WATTS BAR NUCLEAR PLANT (WBN) UNIT 1 - RESPONSE TO NRC QUESTIONS ON TVA'S
QA RECORDS CORRECTIVE ACTION PROGRAM (CAP) PLAN, REVISION 4

RESPONSE TO NRC QUESTIONS OF JANUARY 30, 1992

CONCERNING TVA'S QUALITY ASSURANCE RECORDS CAP (REVISION 4)

SECONDARY DEFICIENCY FRACTION FOR ANSI TYPE H05,
AS LINEAR COMBINATION OF ELEMENTS 10 AND 12

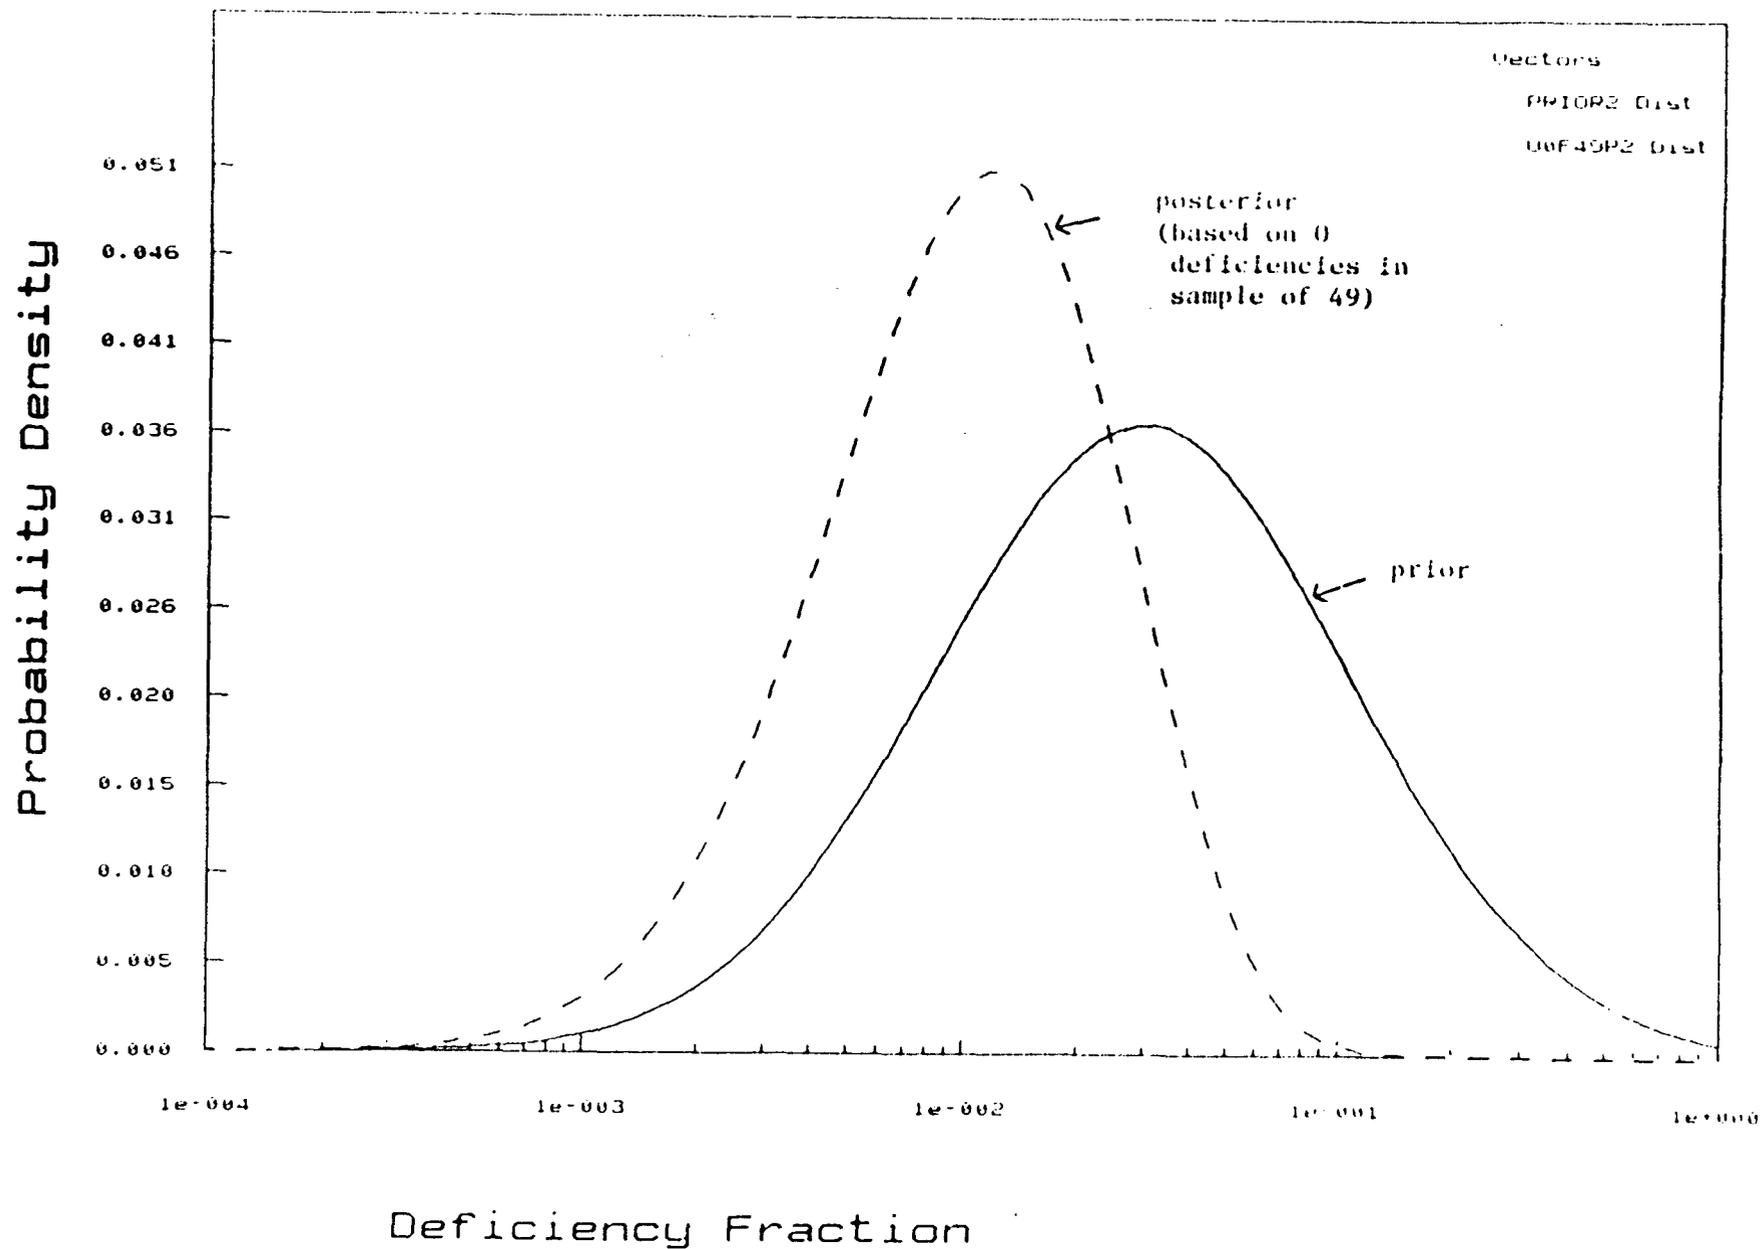
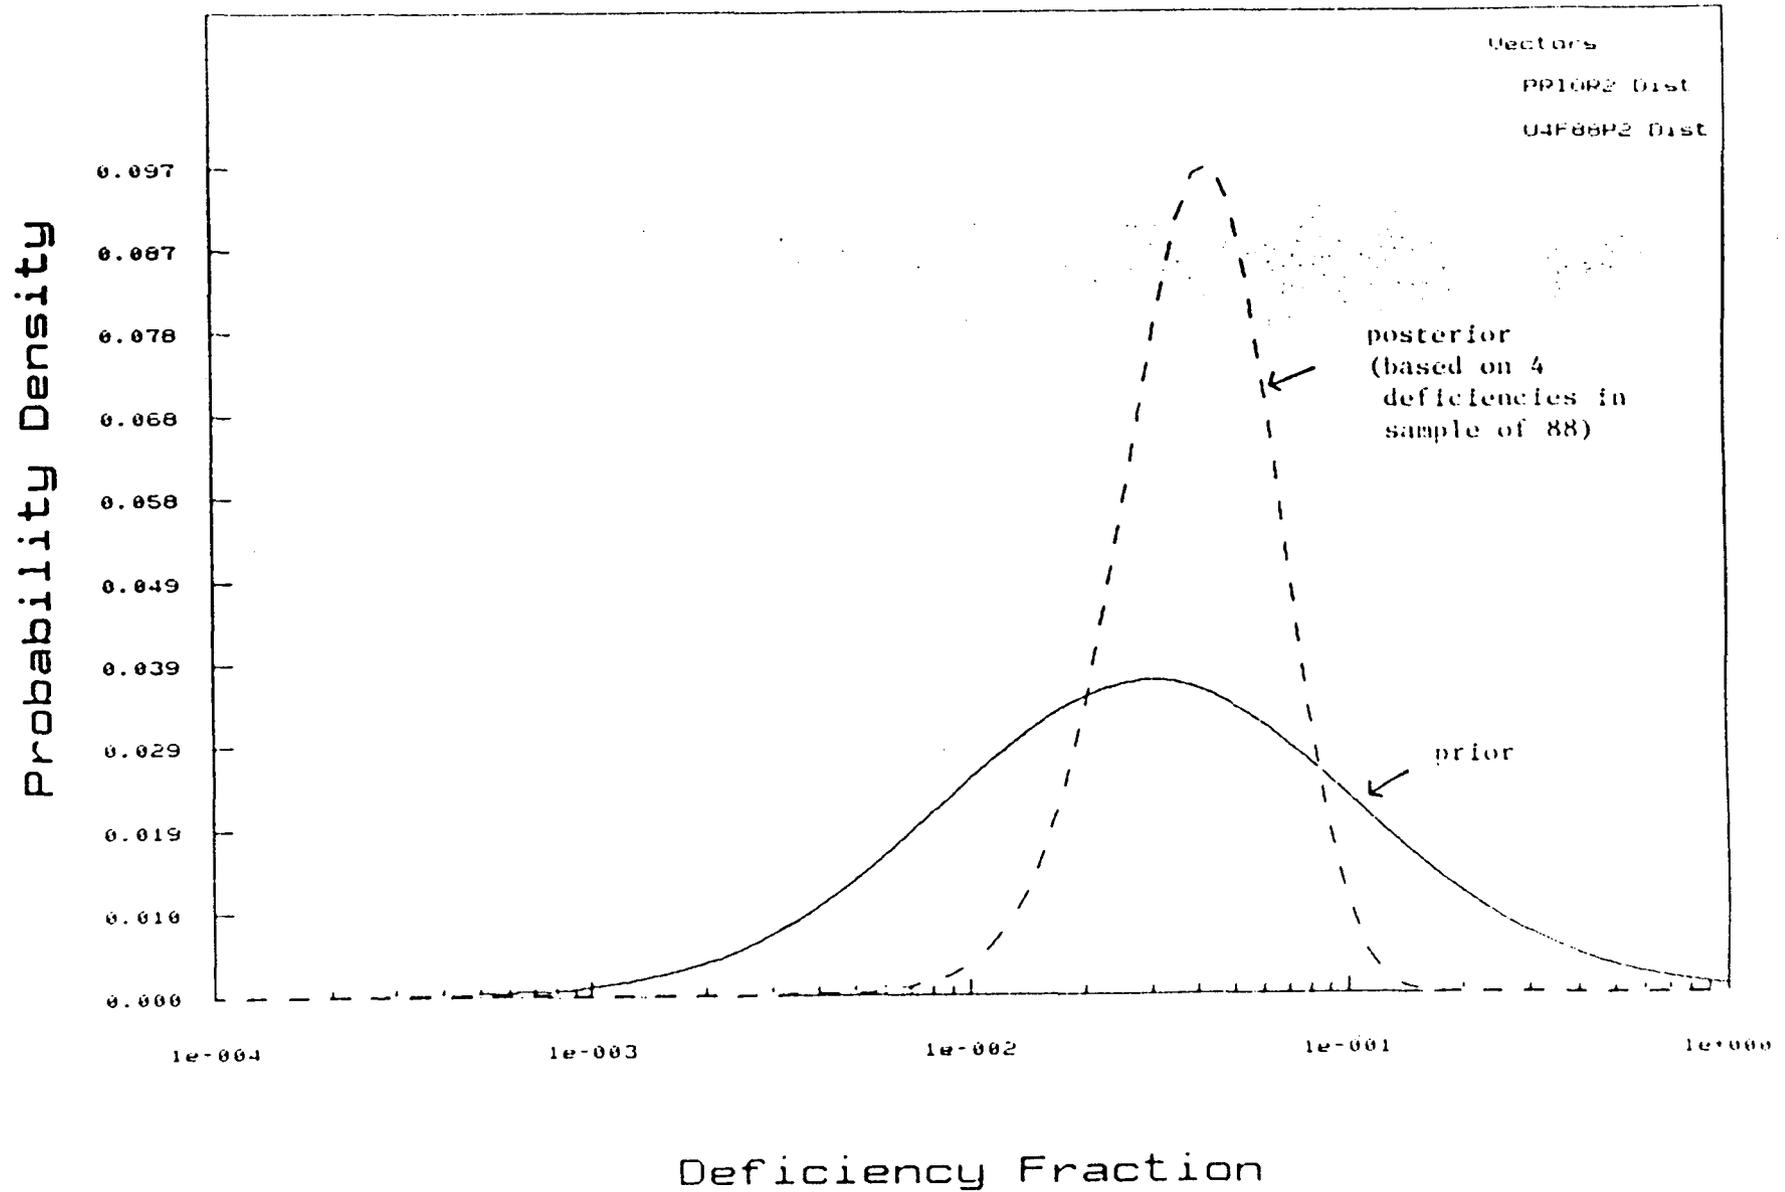
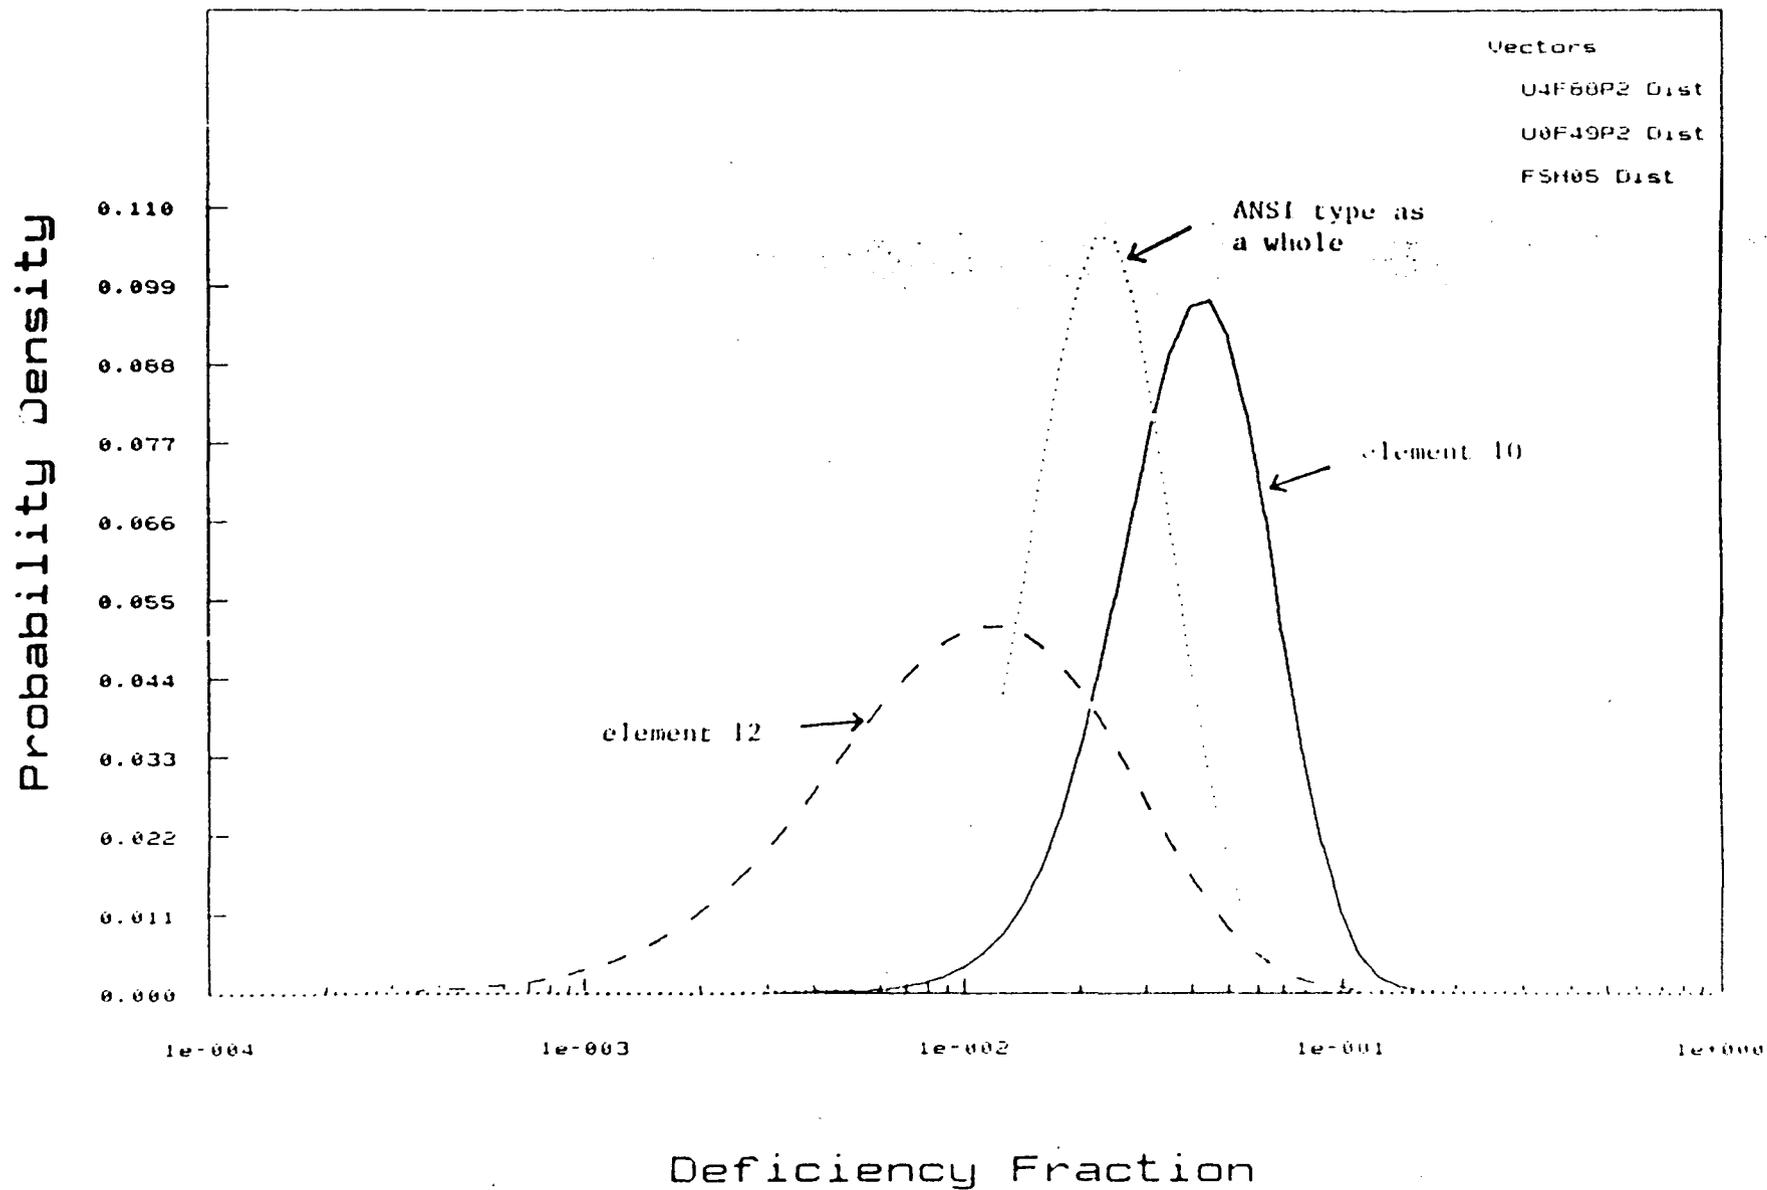
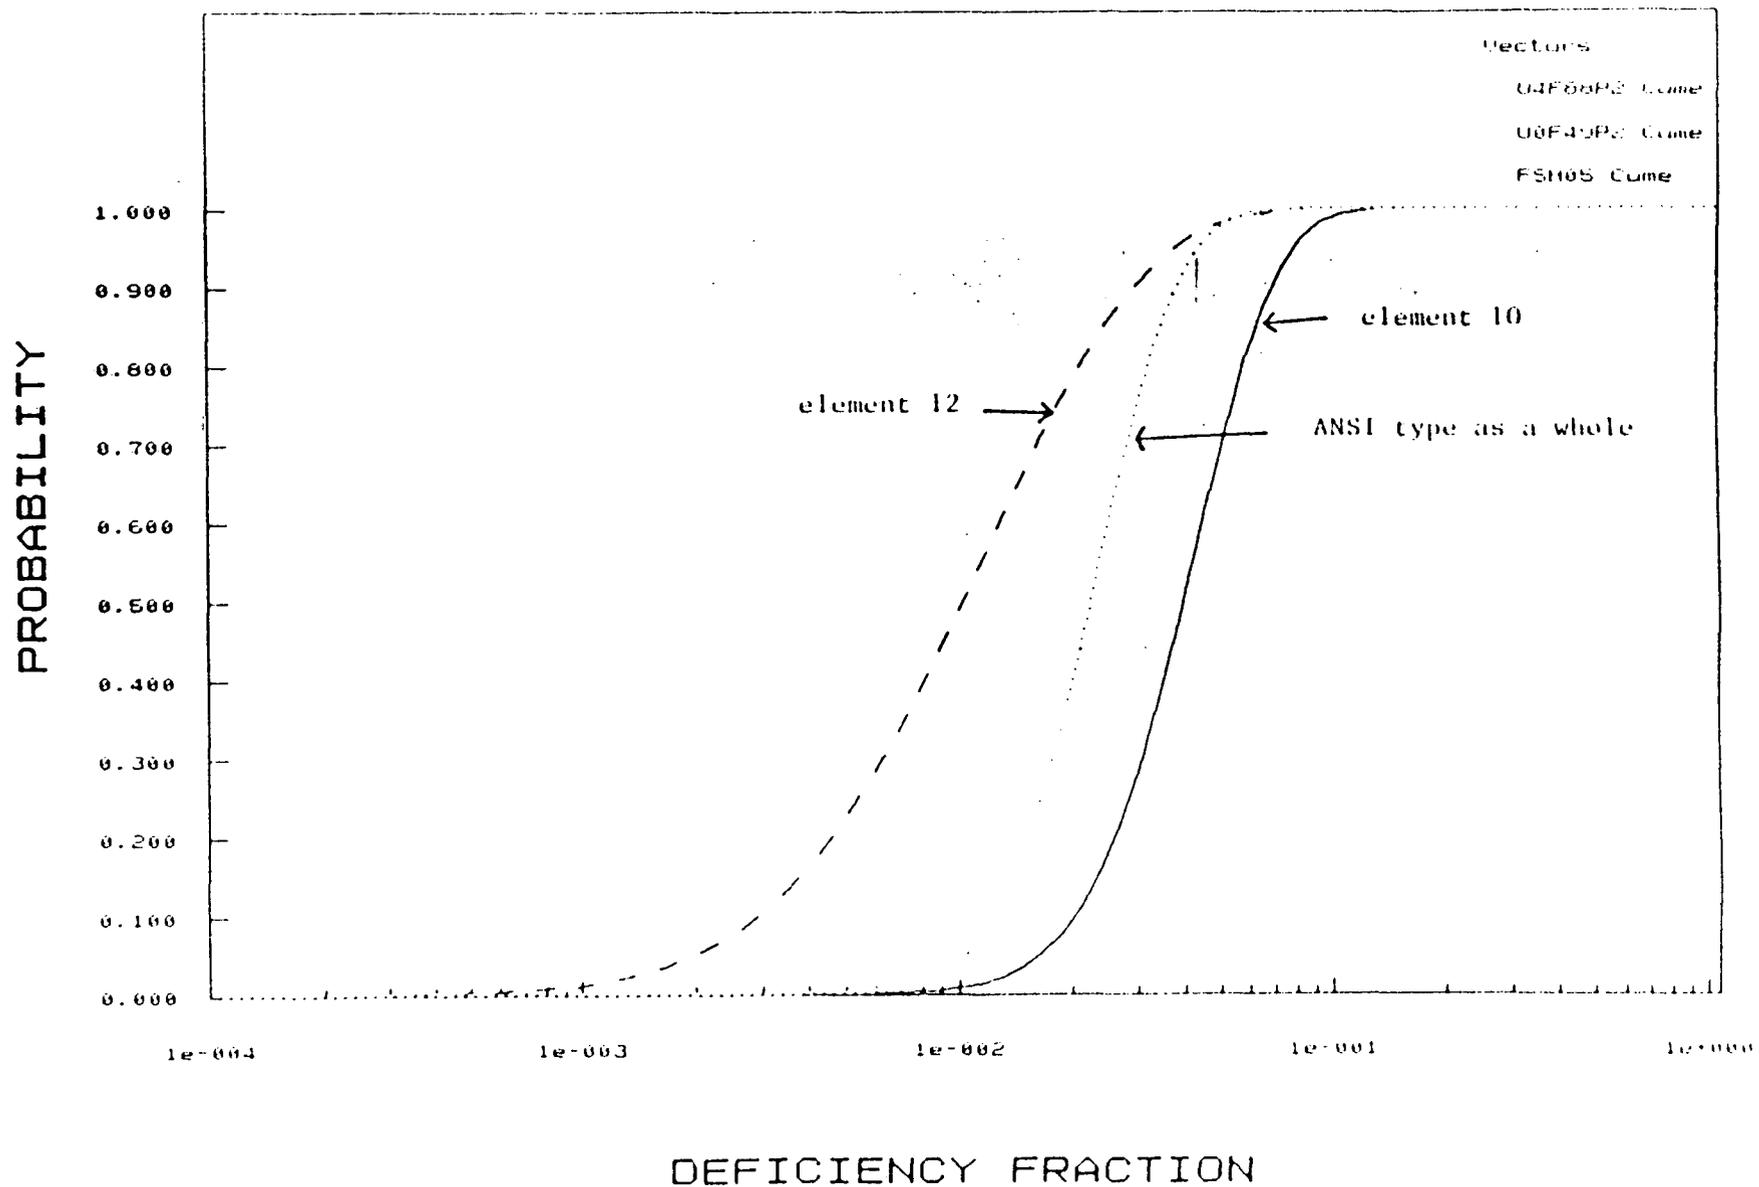
TVA responded to NRC's earlier question 13E by letter dated May 10, 1991. The weighting procedure described at the top of page 3 of CAP Attachment 6 (the ASRR) is taken from Reference 3 of the May 10 letter. We were unable to find Equation 2 of the weighting procedure in this reference. Explain the use of the equation.

Figure 1 shows the results for element 10. The prior curve "PRIOR2" is updated with the evidence of 4 deficiencies in a sample of size 88 to produce the posterior shown.

Figure 2 shows the corresponding results for element 12, using the sample evidence of 0 deficiencies out of 49.

Figure 3 shows the results of combining the posterior curves for elements 10 and 12, through equation (1), to obtain the final curve for f_T^S , the secondary deficiency fraction for the ANSI type as a whole.

Figure 4 shows the same results as Figure 3, but plotted in cumulative form. From this figure we read off 95% confidence that the deficiency fraction is less than 5%, easily meeting our criterion of 95/10 for secondaries.
